SAF Achsen mit Haldex Scheibenbremse, Scheiben \varnothing 430mm SAF Axles with Haldex Disc Brakes, Disc \varnothing 430mm

Sichtbare Merkmale der unterschiedlichen Bremsausführungen Visible features of the both brake types

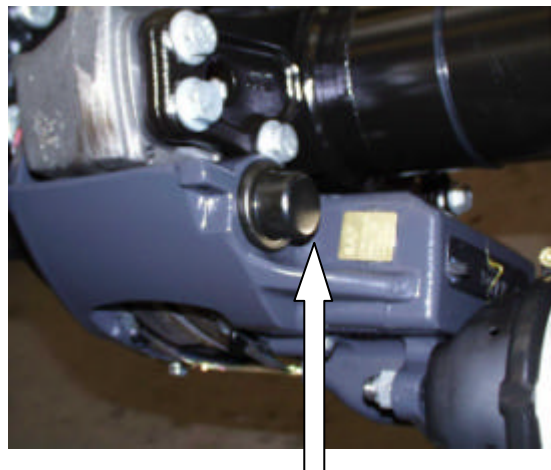
Im Zuge der Produktpflege wurde die Haldex Scheibenbremse überarbeitet.
Die Bremsenkennwerte sowie die TDB Nummern bleiben unverändert.

Bremse „alt“ mit Faltenbalg
„old“ brake with rubber boot

Bremse „neu“ mit Stahlkappe
„new brake with steel cap

Due to improvements in the product, the Haldex disc brake was redesigned.
The brake code and TDB-No. remain the same.

Es erfolgt keine Änderung der Achs- und Aggregatsachnummern. Im Ersatzbedarf kann die neue Bremse für die alte Ausführung verwendet werden. Es wird empfohlen, bei Austausch beide Bremsen einer Achse zu wechseln. Innerhalb eines Aggregates können Achsen mit der alten und der neuen Bremse montiert werden.

Axle and suspension numbers remain the same. The new brake can replace the old specification in spares. It is recommended when replacing, both brakes should be changed on one axle. Old and new brakes can be used within one suspension.
